S. S. Palmas  
Belfast Report No. 3492  
S. S. Lord Londonderry  
Belfast Report for Freeboard No. 3510  
And Tinsbury No. 3510

PROPOSED COMPENSATION FOR  
HOLD BEAMS

PROPOSED S.S. 312-0 x 39-0 x 28-3 KEEL TO BEAMS

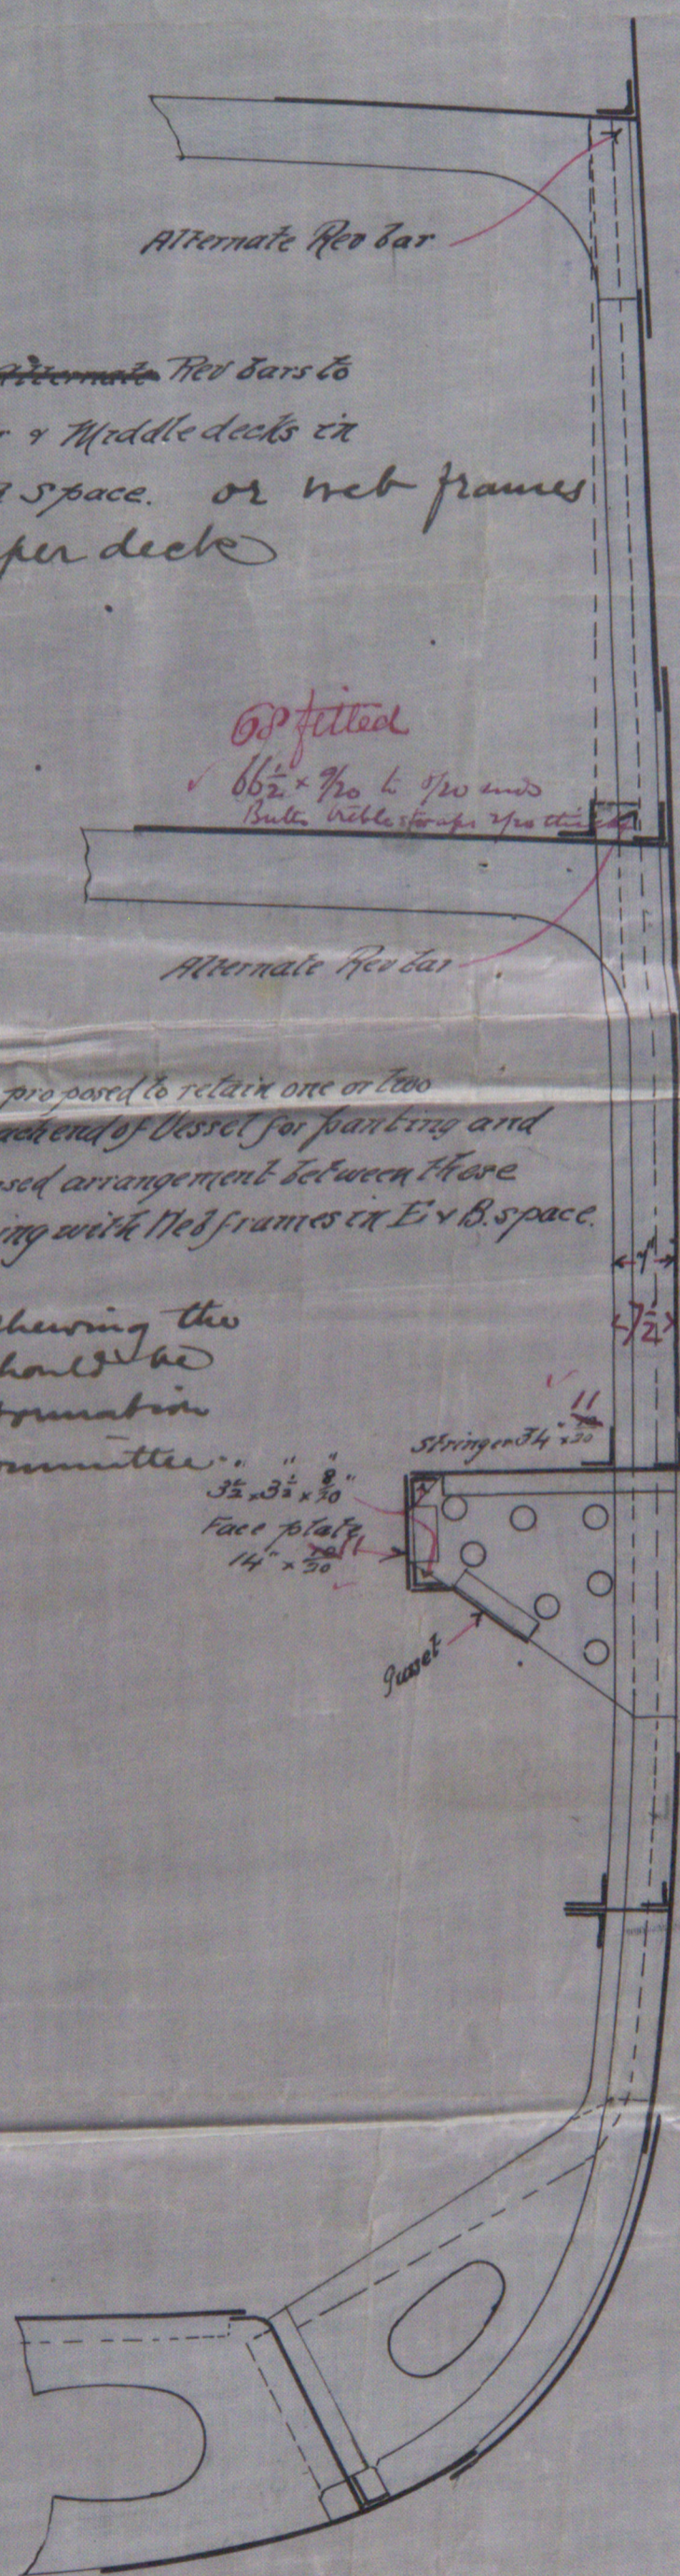
✓ All The Alternate Red bars to  
Upper & Middle decks in  
E & B space. or web frames  
to upper decks

+ NOTE It is proposed to retain one or two  
old seams at each end of vessel for planing and  
to fit the proposed arrangement between these  
points, dispensing with web frames in E & B space.

+ A longitudinal plan showing the  
disposition of beams should be  
submitted for the information  
and approval of the Committee.
